CITY OF
EAST GRAND RAPIDS

RE: Gaslight Investors – Revised Concept Plan and Draft Ordinance & Resolution.

PUD AMENDMENT CONCEPT PLAN

RE: **Gaslight Investors Planned Unit Development Amendment Introduction**
2255 Wealthy St. SE and 515 Lakeside Dr. SE (PPNs 41-14-33-276-032 and 41-14-33-276-029)

PUD AMENDMENT KEY PLAN

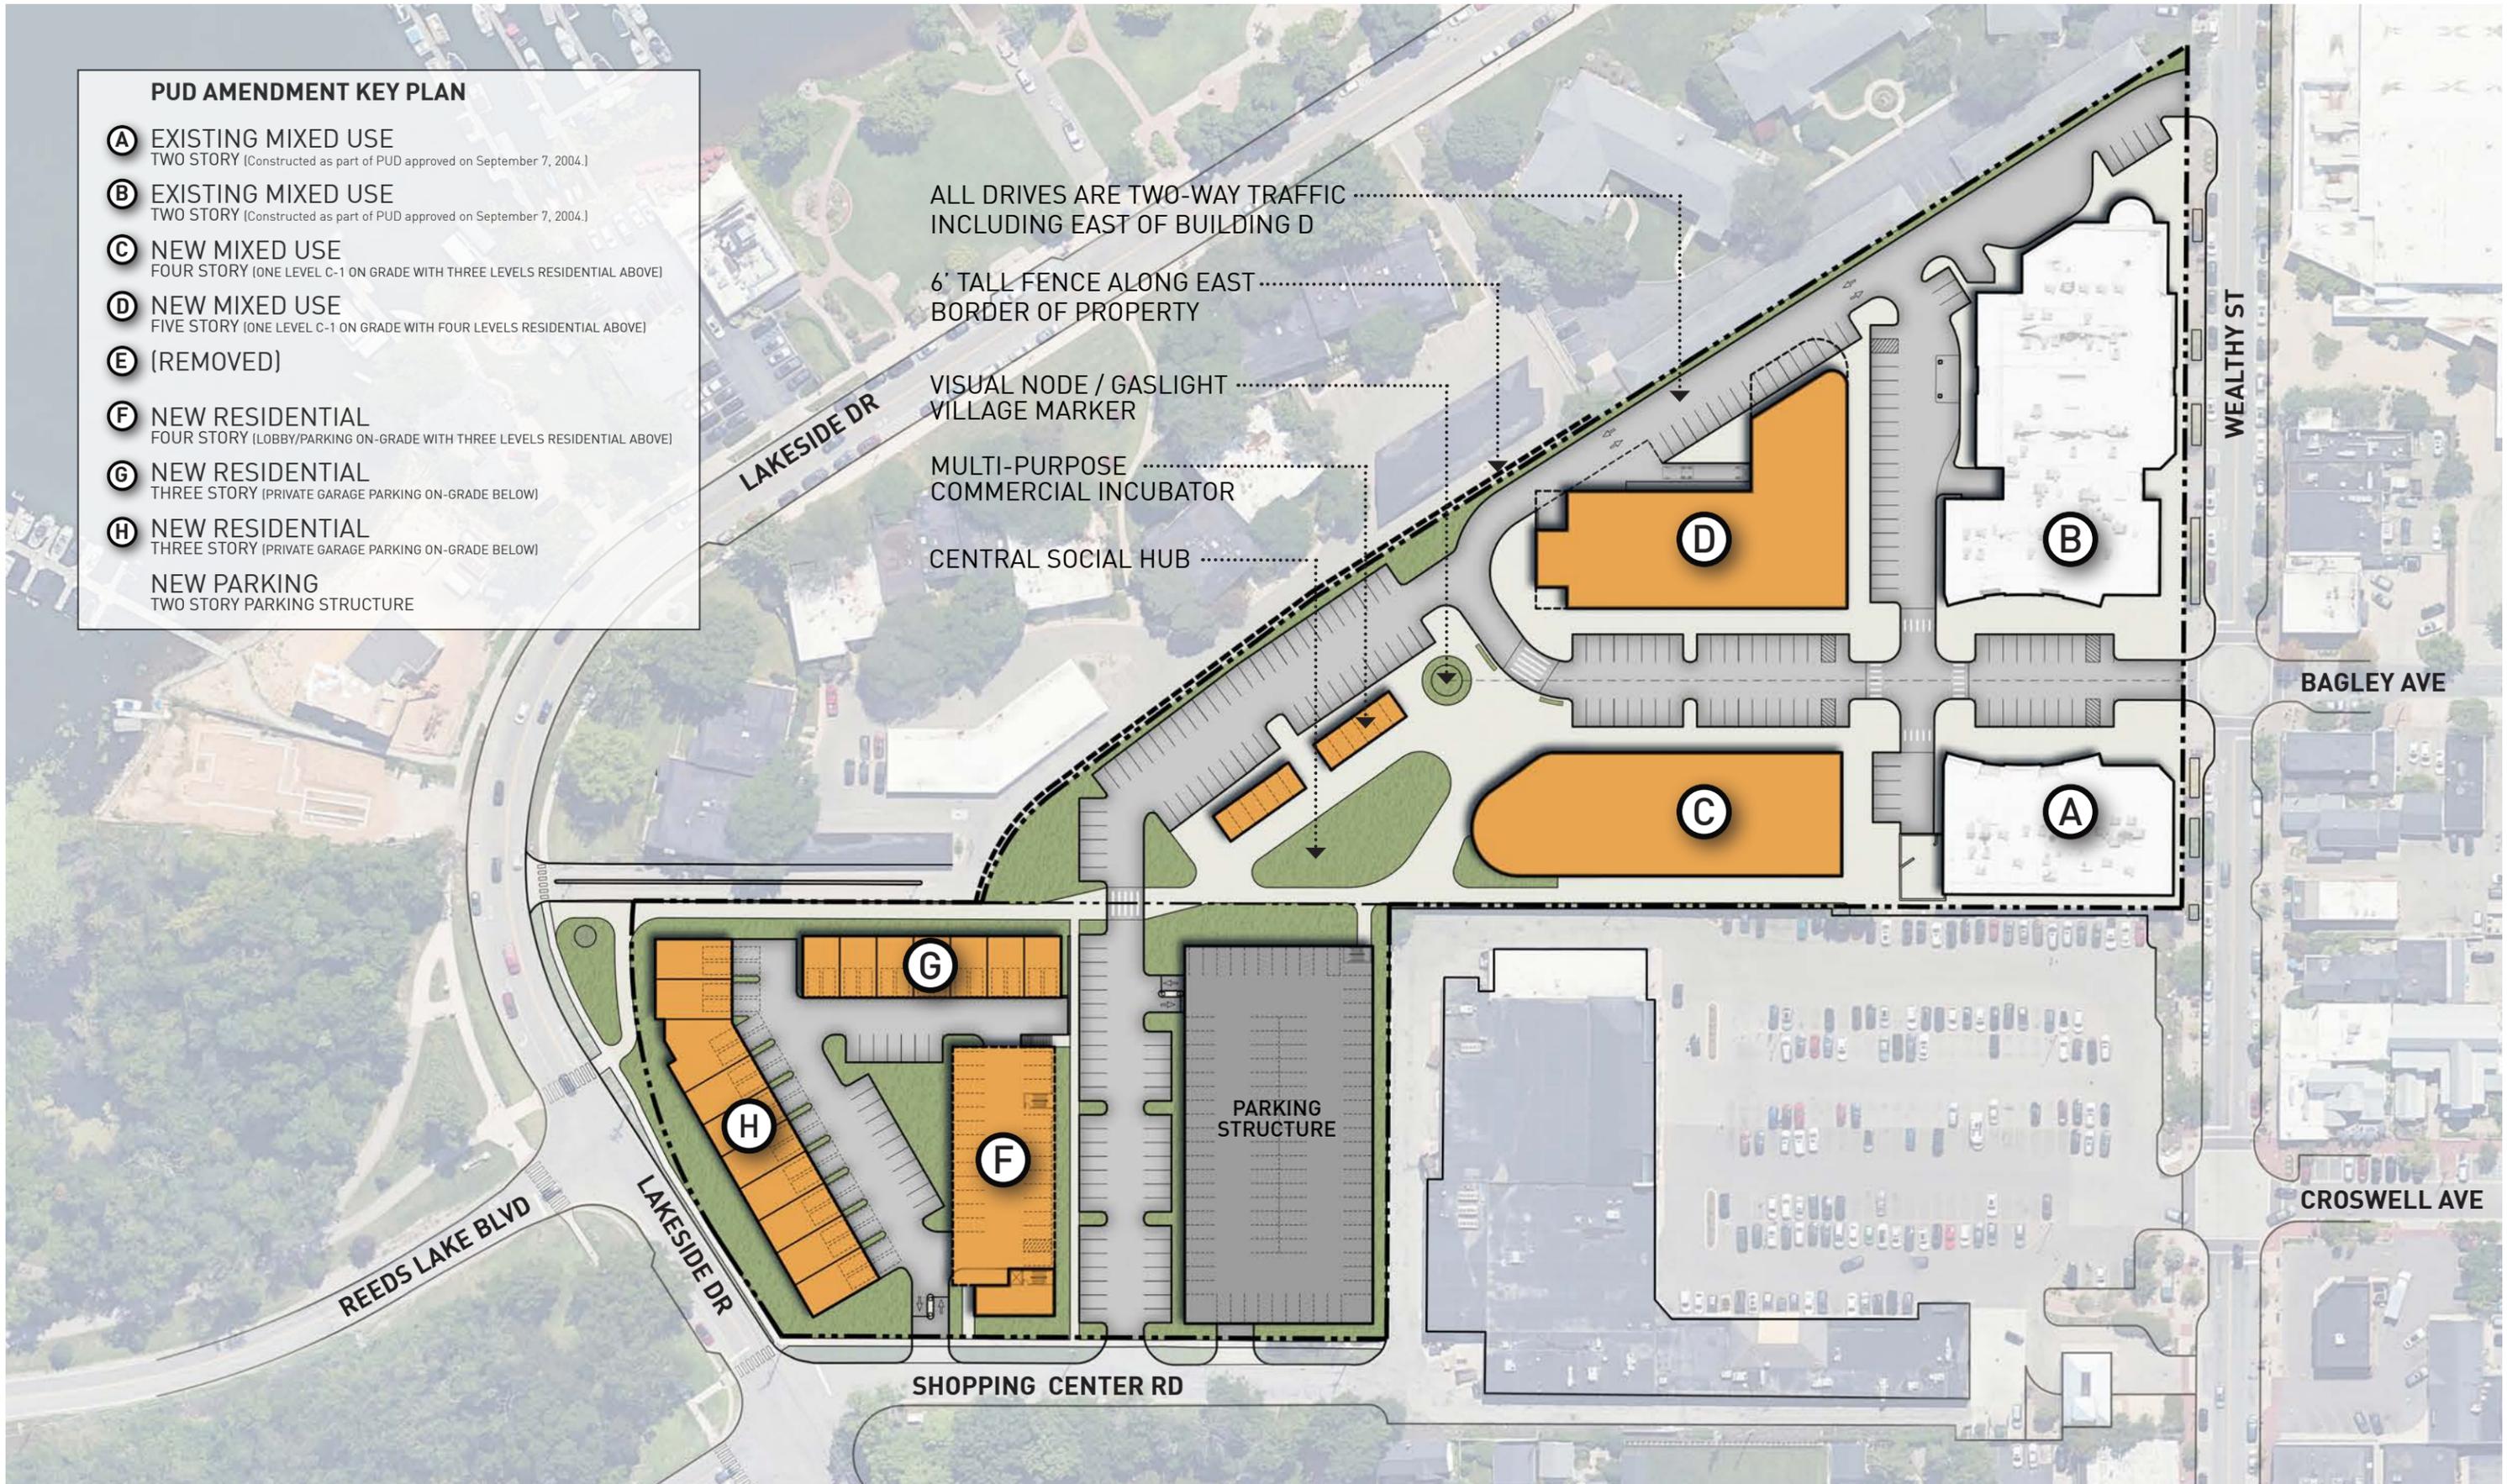
While discussing the requested changes with Gaslight Investors, specifically issues associated with Building E (location & uses) and internal circulation issues, the developers felt submitting a revised plan was the best course of action. Attached is an updated plan which removes Building E and reorientates the vehicular path through the development. Building E's commercial and residential square footage was added to Building C with an expanded footprint. The adjustment has led to the creation of a social hub and multi-purpose commercial incubator space to the north of Building C. Total commercial square footage and requested residential units remain the same.

Section	Requested Change	Status
City Commission Conditions	8. The locations of Building E and the open space around that building, as shown on the attached illustration, shall be adjusted to a mutually agreed upon location within this area in the final site plan and PUD agreement for the 2255 Wealthy Street parcel. This agreement should make the open space a more prominent site feature and improve vehicular circulation through the site. Requested Change – add “public” into section.	With the revised concept plan this language has been removed from the draft.
General	Adding new language noting that all conditions must be met for final approval.	Gaslight Investors has accepted this change.

SUMMARY OF CHANGES COMPARED TO PREVIOUS PROPOSAL (FEB 2024)

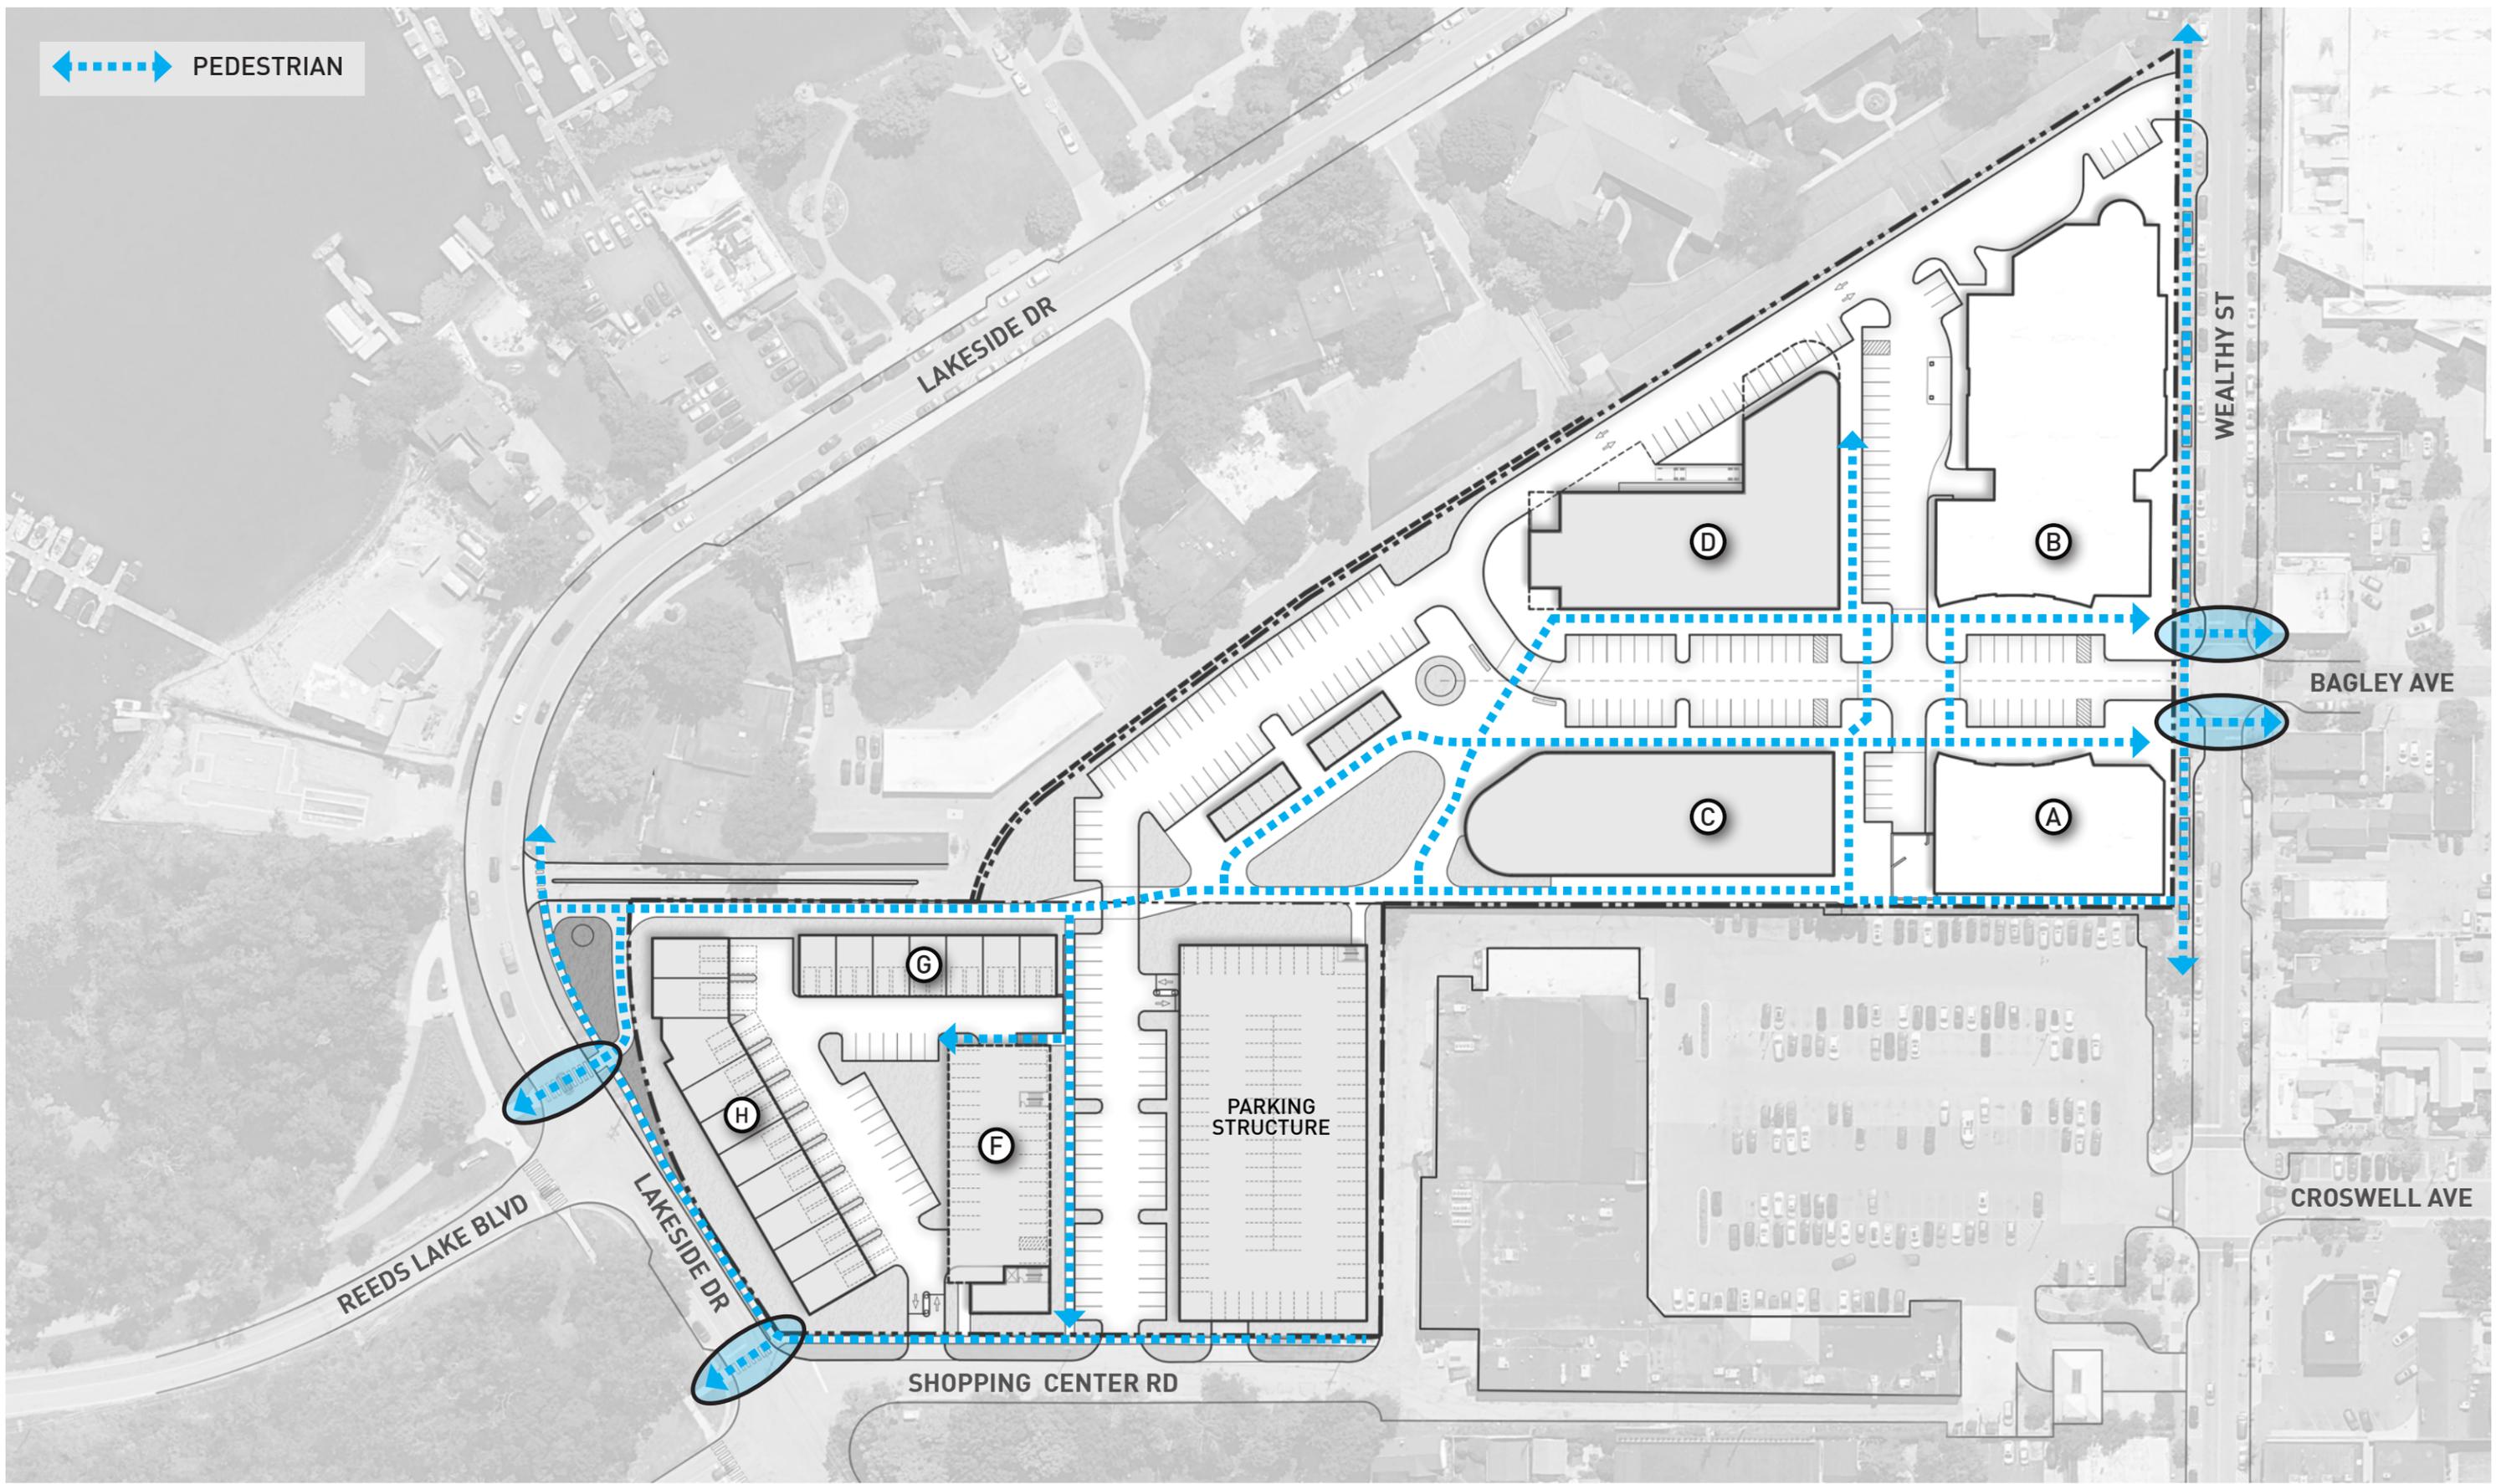
previous (FEB 2024)	proposed (8.26.2025)	CURRENT DESIGN HIGHLIGHTS
Existing C-1 USE AREA	77,500	77,500	CURRENT EXISTING C-1 SPACE IN BLDGS A + B TO REMAIN
New C-1 USE AREA	56,970	32,000	44% REDUCTION - 24,970 LESS C-1
residential units	180	147	18% REDUCTION - 33 LESS RESIDENTIAL UNITS
parking spaces	583	493	PROPOSED PARKING RATIO FORMULA
total bldgs in PUD	8	7	
Bldg C	5 levels	4 levels	REDUCTION OF ONE LEVEL
Bldg D	7 levels	5 levels	REDUCTION OF TWO LEVELS
Bldg E	5 levels	REMOVED	BUILDING E WAS REMOVED FROM PLAN
Bldg F	4 levels	4 levels	NO CHANGE (3 levels with on grade parking below)
Bldg G + H (townhomes)	3 levels	3 levels	NO CHANGE (garage parking below)
parking structure	3 - 4 levels	2 levels	REDUCTION OF 1 TO 2 LEVELS
